AGENDA ITEM 10
PLANNING & DEVELOPMENT SERVICE
PLANNING DIVISION
455 Mountain Village Blvd.
Mountain Village, CO 81435
(970) 728-1392

TO: Mountain Village Design Review Board

RE: Consideration of a Design Review: Initial Architecture and Site Review for a new Single-Family home on Lot 226BR, 242 Benchmark Drive, pursuant to CDC Section 17.4.11.

Grading and Drainage
with
Driveway Plan and Profile

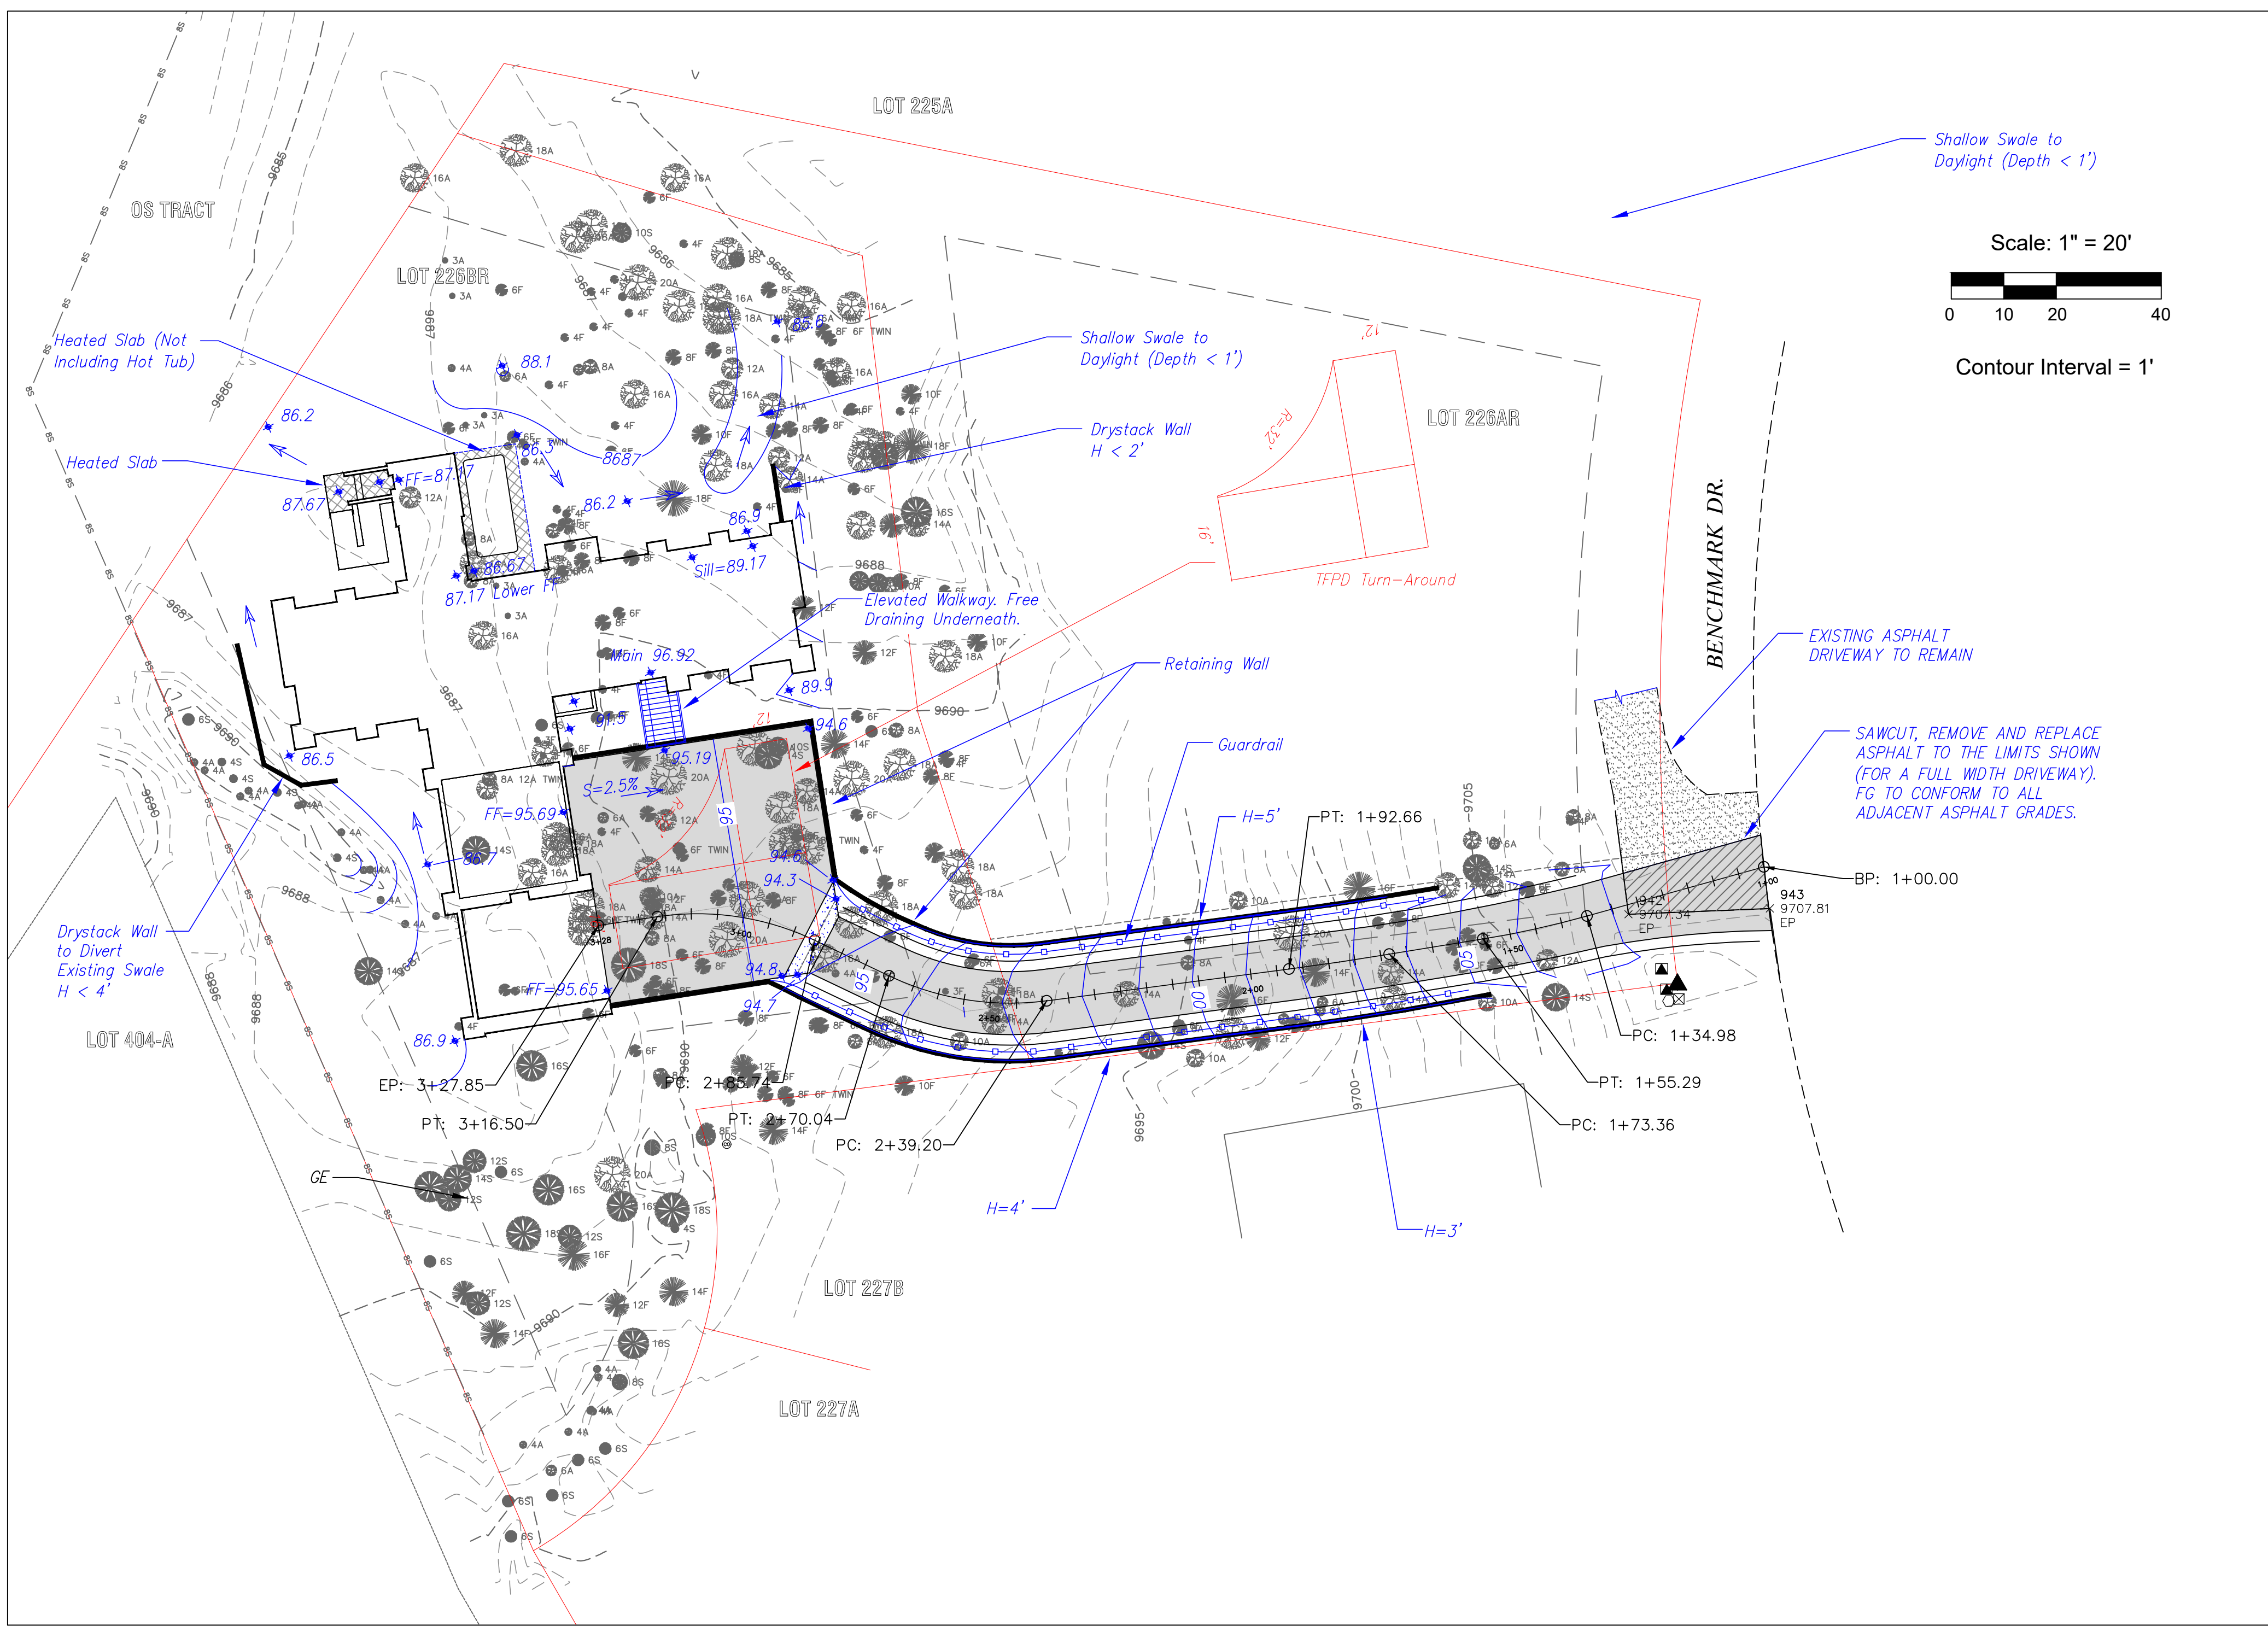
Staff: The civil plans provided indicate that the driveway does not currently meet the width requirements for drives over 150 feet in length. Due to the length, the applicant must provide for a 16-foot paved surface. The shoulders are not a requirement unless required by the fire department. The applicant is aware of this requirement and has indicated that the plans will be revised to modify the shoulders and provide this 16-foot paved driving surface. The driveway grade is demonstrated on page C2, and the grade meets CDC requirements.

1. Drawing C2 shows a “dry stack wall to divert existing swale” and we respectfully request to remove that wall, and divert the runoff water through Lot 404-A. We are requesting this for the following reasons:

- c. The construction of the dry stack wall would require a variance by itself.
2. Drawing C2 shows a driveway retaining wall 5'-0" high and we respectfully request a Design Variation from the maximum 4'-0" stepped wall requirement.

A3.2

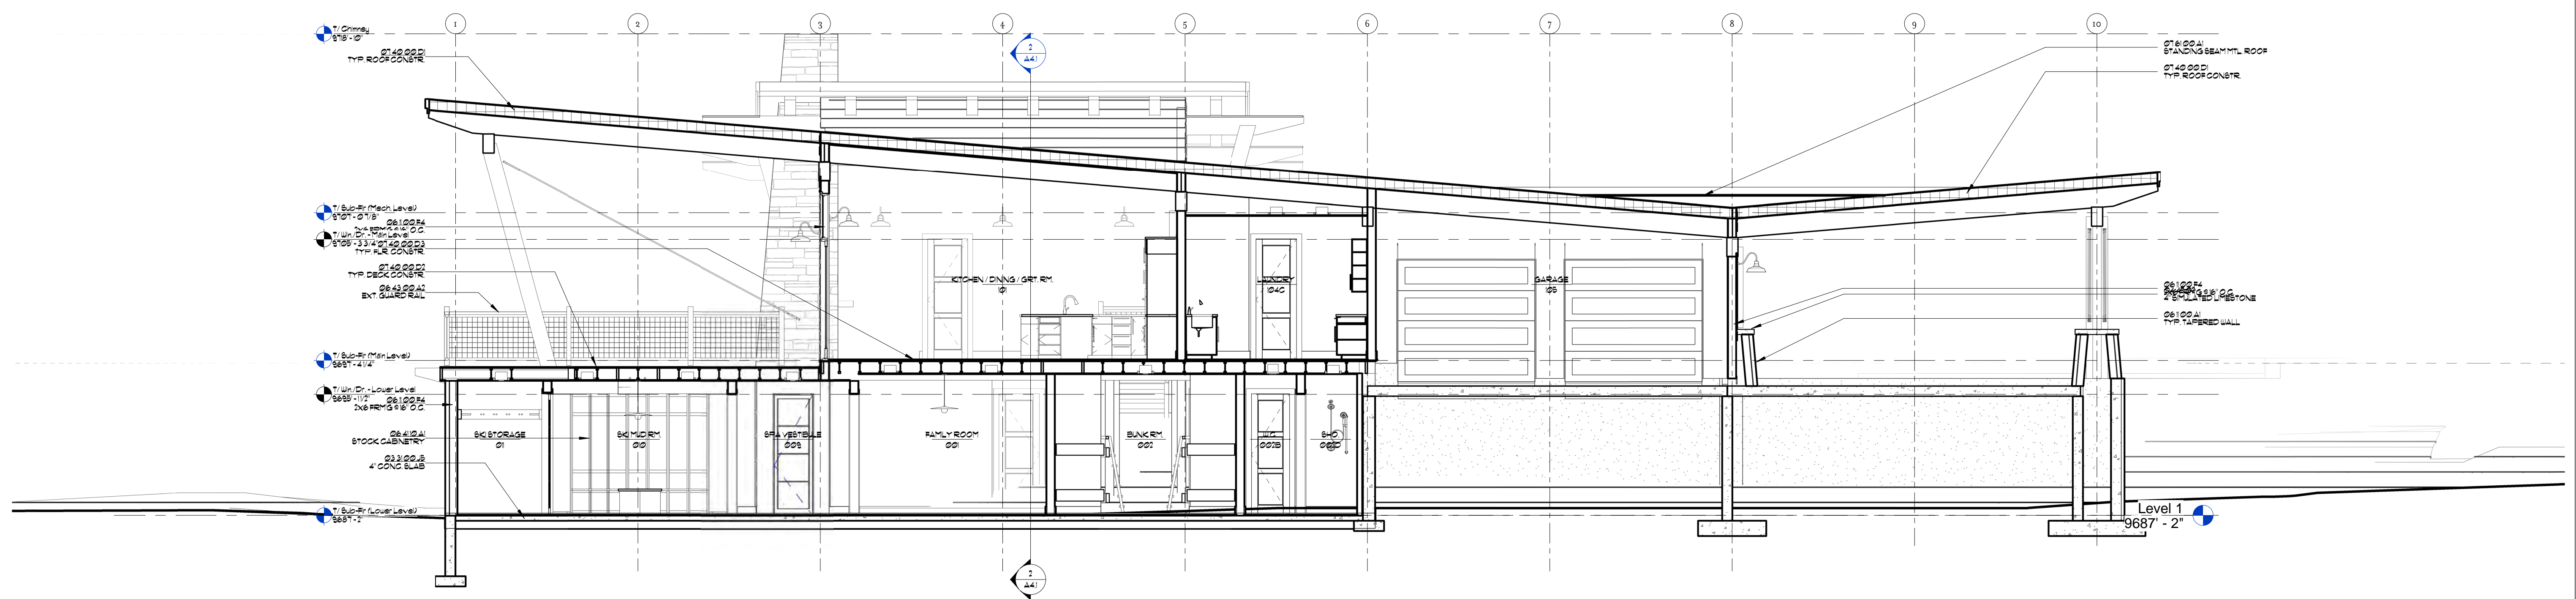
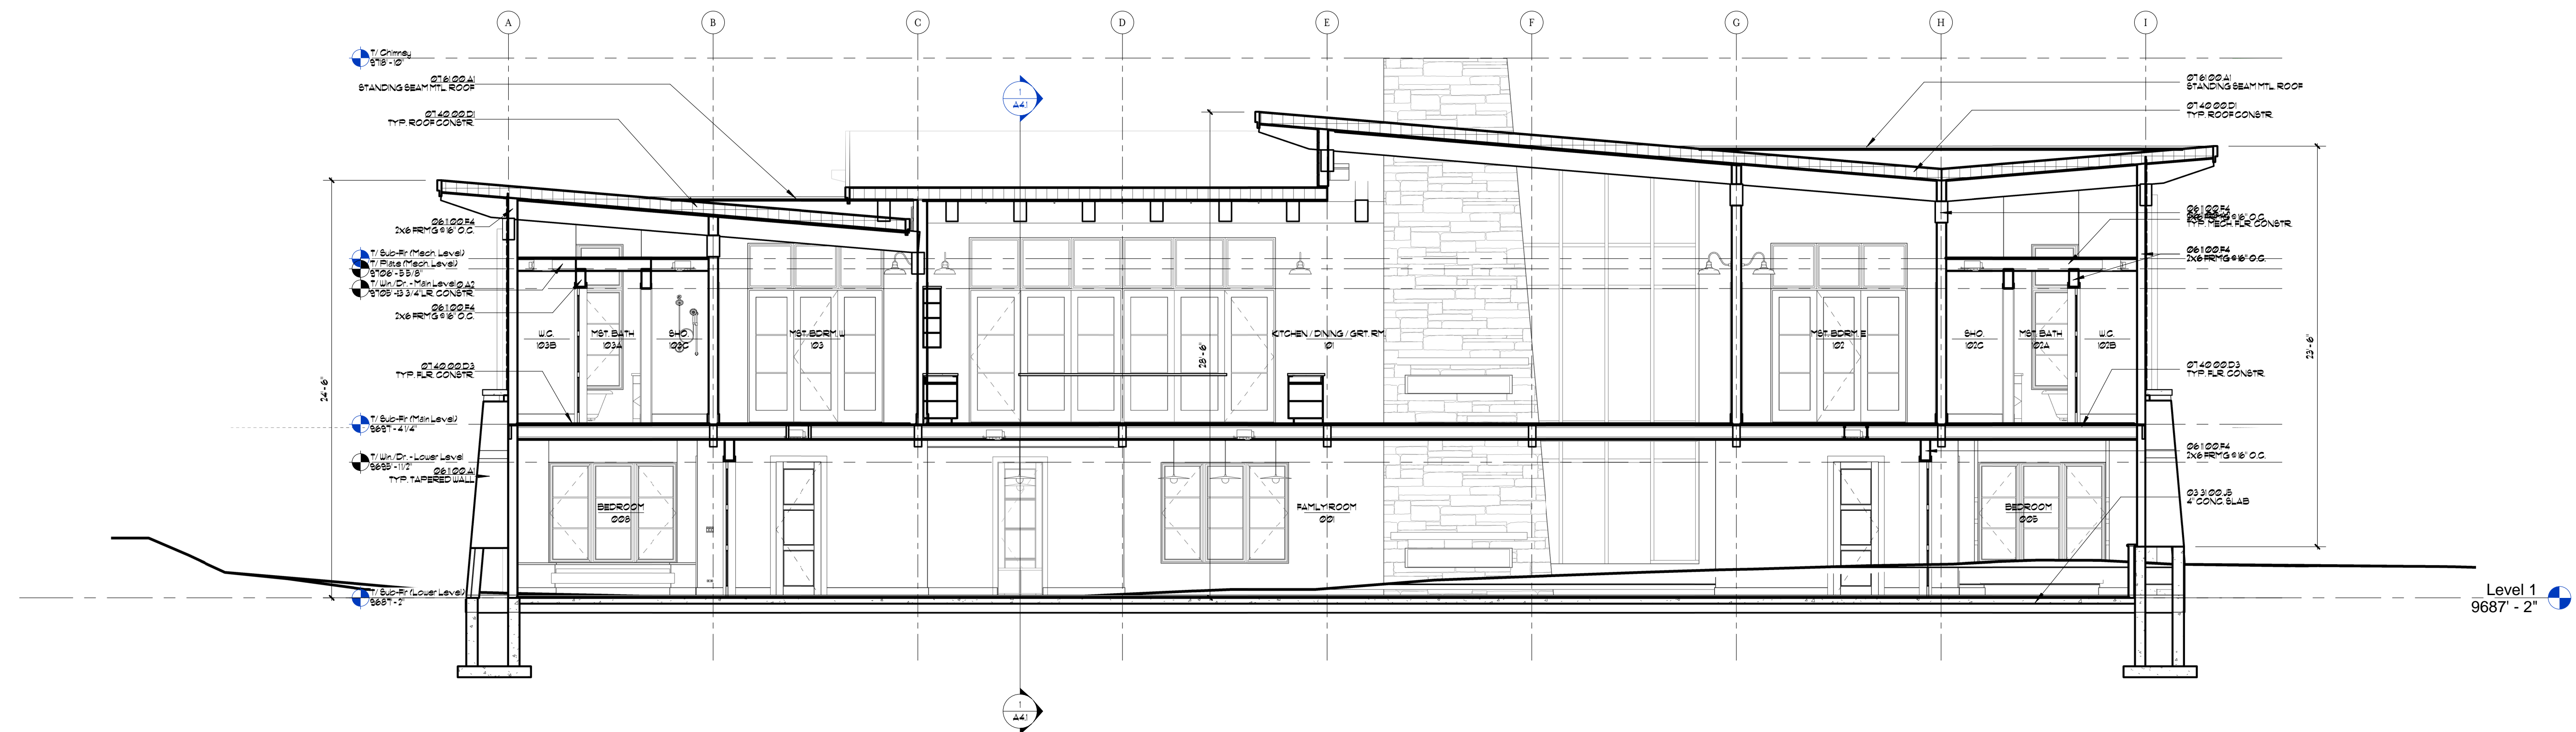
Staff: As part of this application, the applicant has provided both a Maximum Building Height and Average Building Height analysis. Based on the heights provided, the maximum building height is 28 feet from the highest ridge to the grade below. The maximum average height is 24.89 feet. Both of these heights comply with the CDC

requirements. Additionally, the applicant has provided a parallel plane analysis demonstrating that no portion of roof forms penetrates the 35-foot parallel slope height allowance. It should be noted that there appears to be some discrepancy between the parallel plane projection and the most restrictive grade. The most restrictive grade is the lesser of the existing and proposed grades. With that, the heights still appear to meet CDC requirements but prior to submittal for Final Architectural Review (FAR), the applicant shall revise Page A3.2 per these comments.

- 1) Prior to submittal for a Final Architectural Review, the applicant shall revise the parallel plane analysis to demonstrate both existing and finished grade projections.
